Darling Square North Plot + The Square Response to Submissions (RTS) Report

14076 - SSDA10(RTS)

December 2016

Figure 1: DA Areas

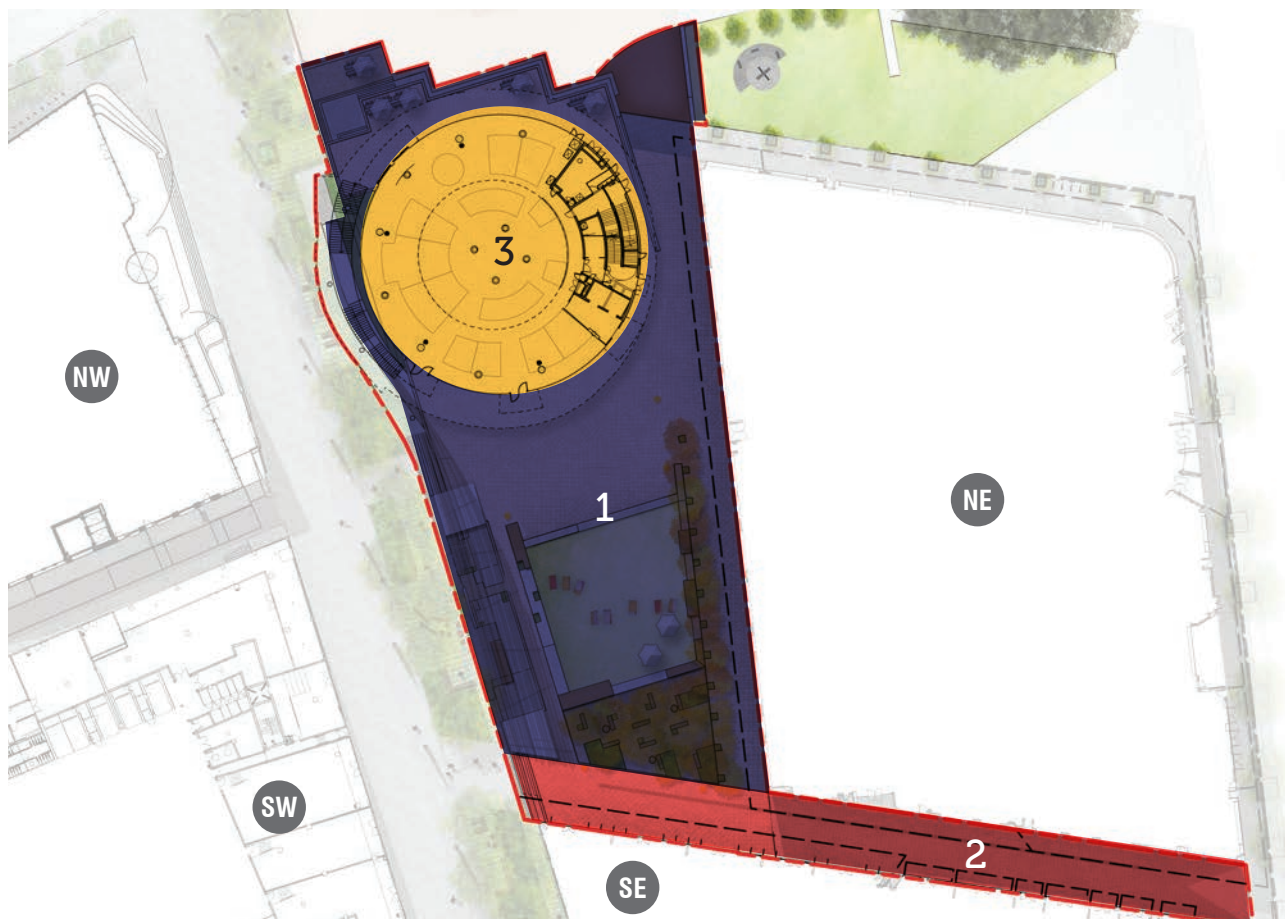
Submission from the Department of Planning and Environment: Confirm whether the site area (4,600sqm) includes or excludes Little Hay Street.

The area referenced in the DA of 4600m² includes Little Hay Street. Since lodgement, further consideration has been given to the precinct's interface with the existing Darling Harbour precinct to the north. In this regard the site area is proposed to be expanded as part of this response to submissions. See below.

1. The Square (3090m²)
2. Little Hay Street (830m²), and
3. The North Plot (1070m²)

TOTAL - 4990m²

Figure 5: Turf area and paths of travel

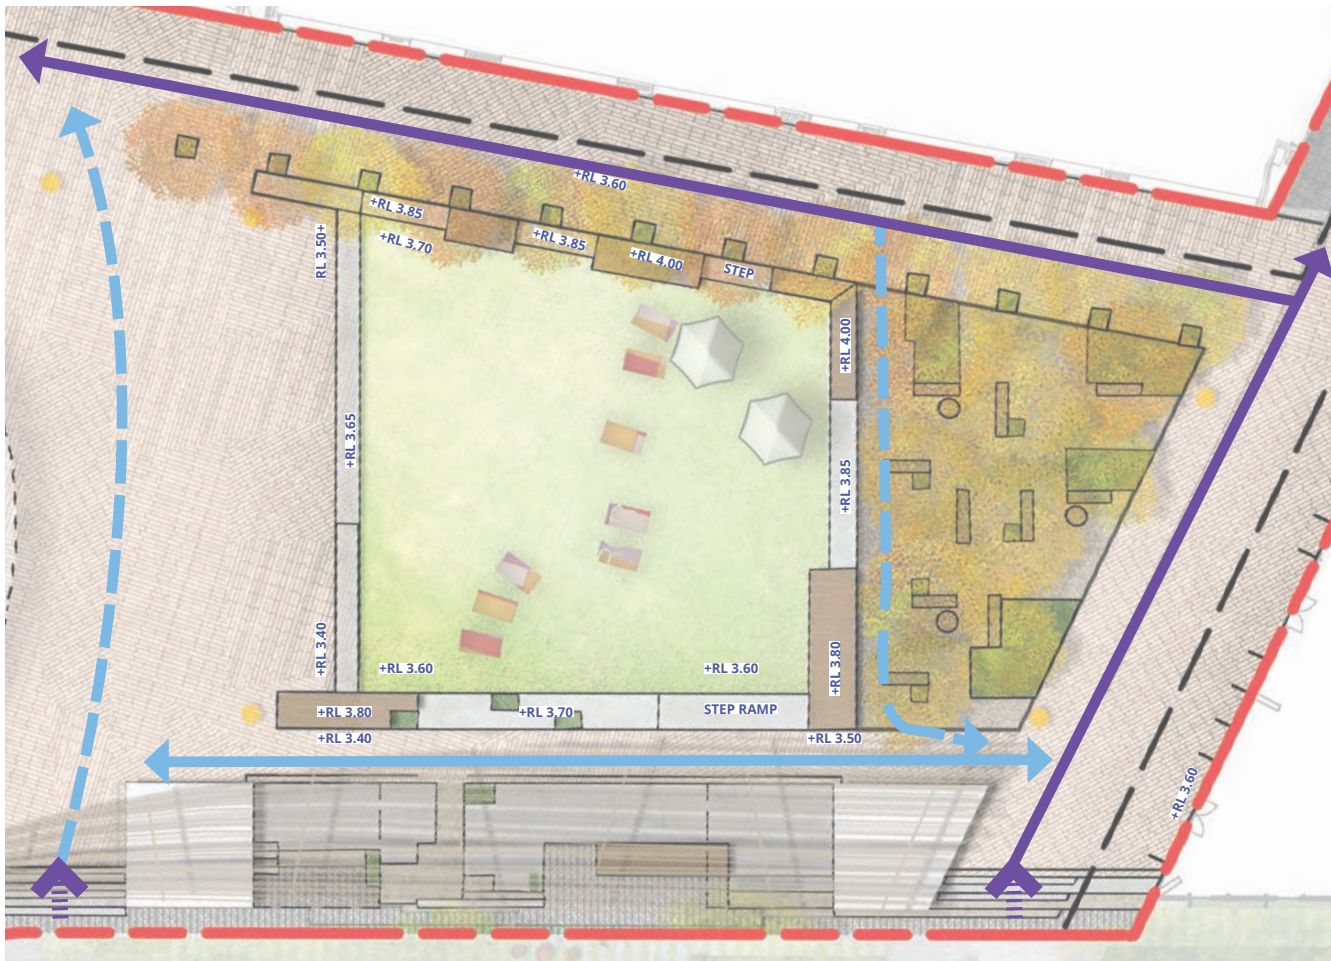
Justify the provision of grass within the public urban square, particularly whether this is a viable landscaping option given the size of the space and the likely level of footfall/traffic.

The turf has been situated to the south of the Square so that it receives good sunlight, and is lifted above the surrounding square so that it is viewed as a destination rather than a shortcut. The eastern, southern and western edges will act as low seats, 300-400mm high, so that users can perch on the edge of the turf. The edges will be punctuated by small steps and step ramps to enable users to access the turf area from all sides, without it being viewed as a shortcut. At the northern end, a low, nom. 150-200mm high edge separates the turf from the height of the paved zone, allowing easy access onto the grass whilst still maintaining its presence as a destination.

Generous walkways to the east and west of the turf in a north-south direction are intended to allow users of The Square to get quickly and efficiently throughout the space, further cementing the lawn's place as a destination.

These above measures help prevent the formation of desire lines and encourage pedestrian movement through the vibrant, pedestrian walkways to the north, south, east and west. It is anticipated that this turf area will require a detailed maintenance regime, however this is considered appropriate to the scale and density of the precinct and a worthwhile investment for the value it will add to the space.

Figure 7: Market Layout

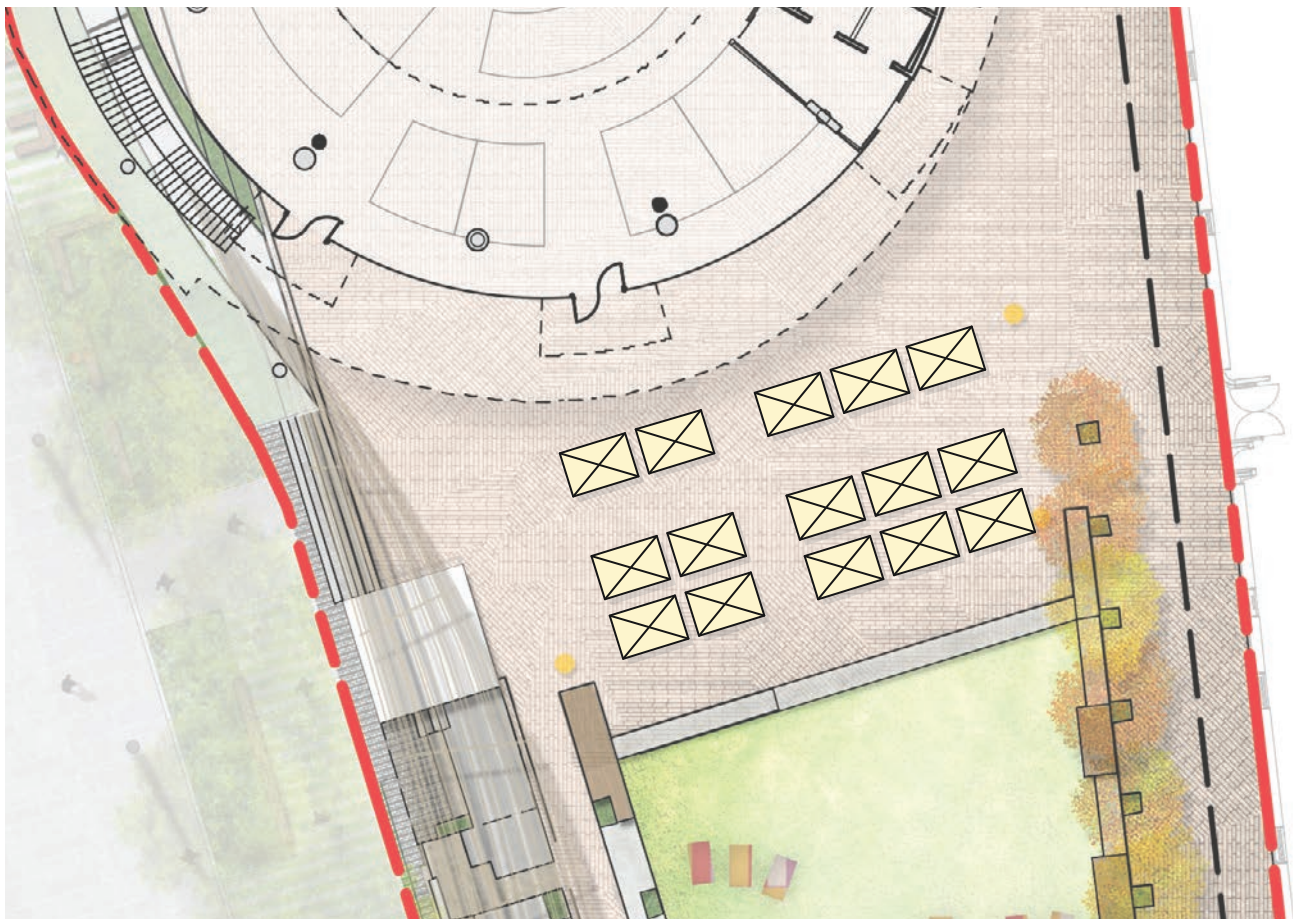
The proposed indicative layout for markets in the Square is not efficient or customer friendly in the City's experience. Market layouts should be approached in regular geometric patterns. Power supply, water supply and vehicle access should be designed accordingly.

The market layout has been further developed and is outlined in the revised DA response to submission drawings. Services overlays have also been amended and are reflected in the revised response to submission drawings.

The design provides a reasonable area for flexible-mode use by markets and events, and servicing for this purpose.

Power and water are proposed to be supplied to The Square. Refer to Arcadis' report and drawings. Refer to TTM's traffic report for vehicle servicing and access.

Figure 15: Revised ramp access from The Boulevard to The Square

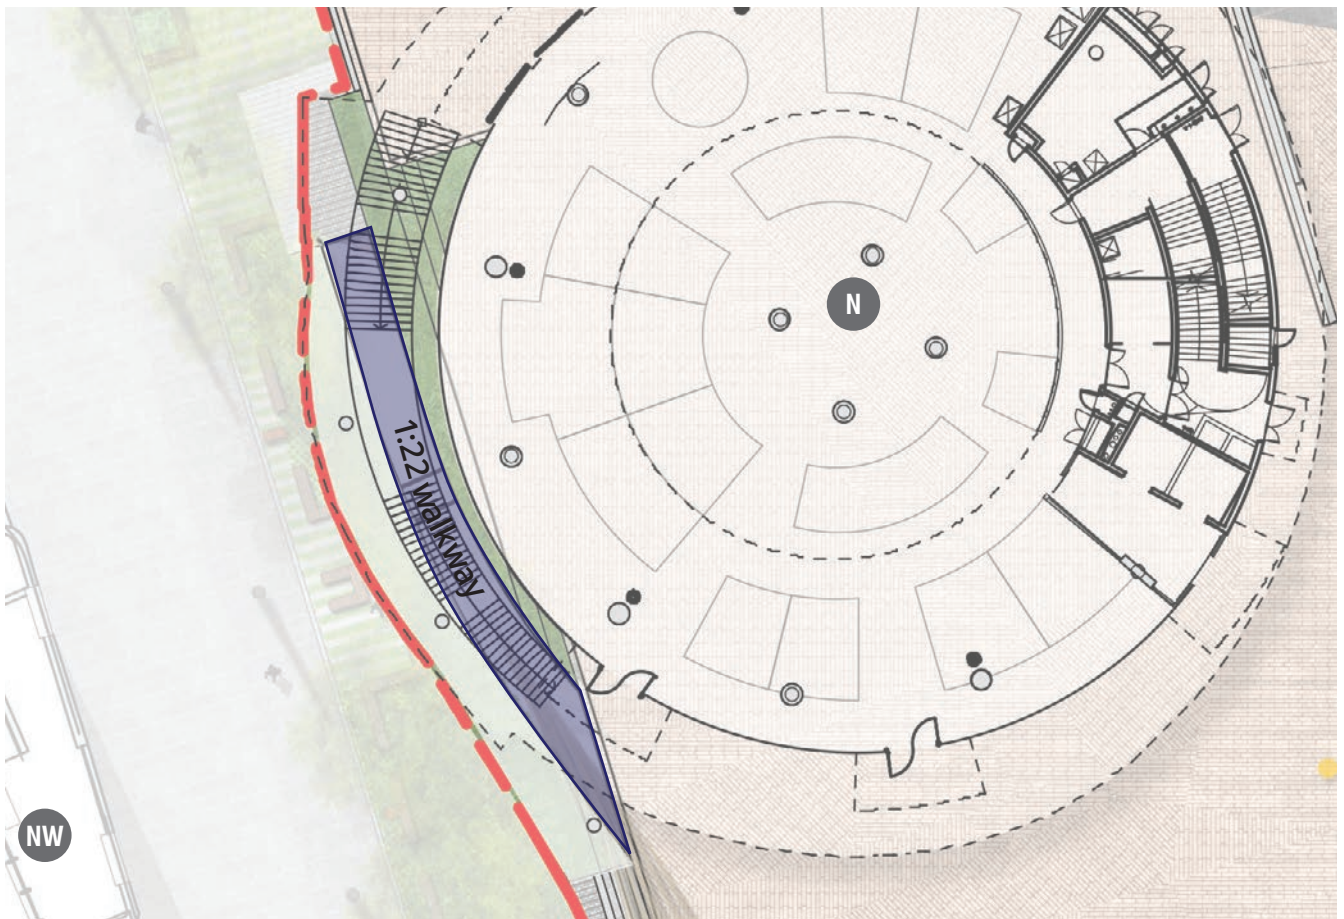
- **the encroachment does not restrict pedestrian sightlines looking north and south along the boulevard at the western extent of the North Plot building;**

From a public domain perspective the accessible ramp is the only encroachment on the boulevard and has been designed as a low lying element that sits below eye level and does not restrict pedestrian sightlines looking north and south along the boulevard. Refer to Figures 18 and 19. The ramp has been designed to hug the north plot building creating a seamless connection between the boulevard and darling square.

Pedestrian connectivity has been enhanced from the original DA by shifting the DDA switchback ramp from being wedged between the two retail pods to skirting the western edge of the north plot. This frees up pedestrian movement between the Boulevard and The Square whilst enhancing pedestrian flow along the Boulevard. Refer to figure 28. Refer to Design Amendment 3 for further details.

A datum of approximately 1m has been created for the ramp and any low level planting and furniture, to maintain the perception of openness. The ramp requires an open handrail for DDA access that has been designed to maintain the feeling of openness.

Figure 23: Circulation

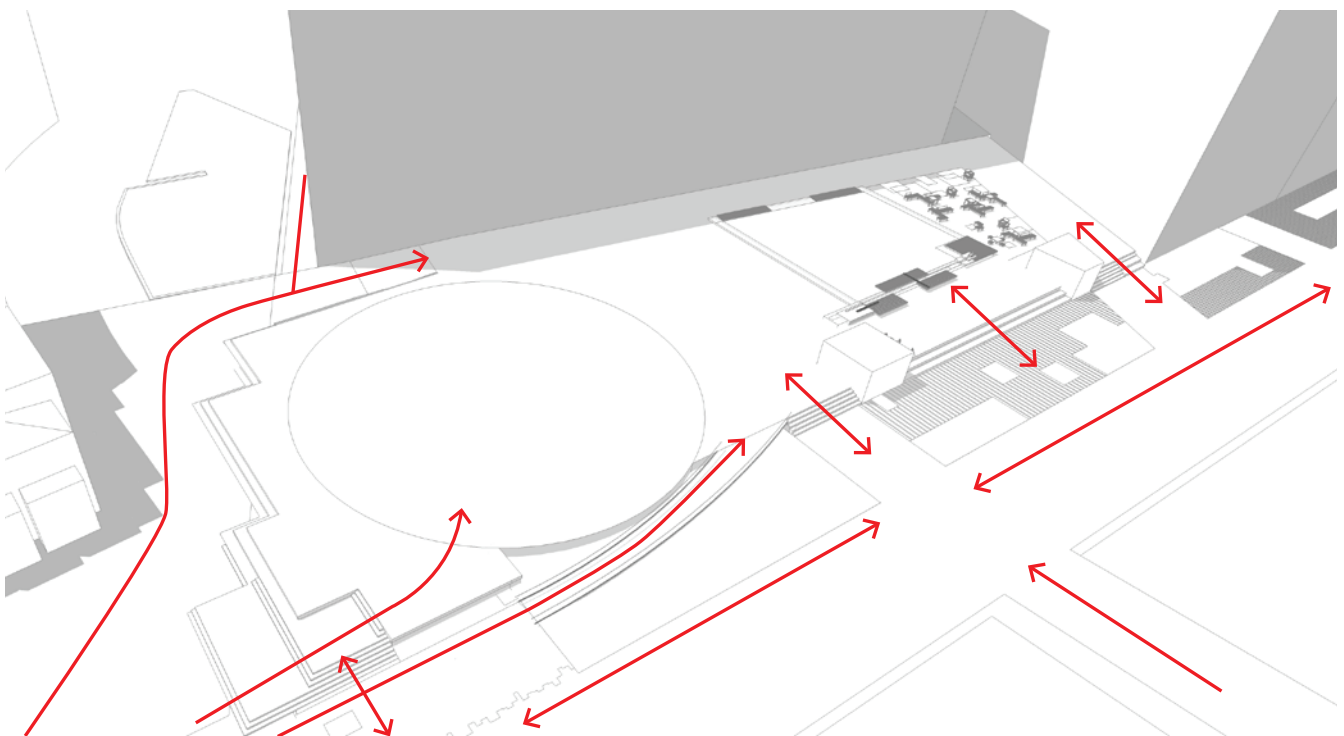
- **any encroachment does not result in an unacceptable visual pinch-point along the boulevard.**

The ramp closely hugs the north plot and as it follows the shape of the building does not create a visual pinch-point along the boulevard. In particular congestion is unlikely to occur due to the linear shape of the ramp that flows with the flow of pedestrians walking in a straight line. It is not a switch back ramp.
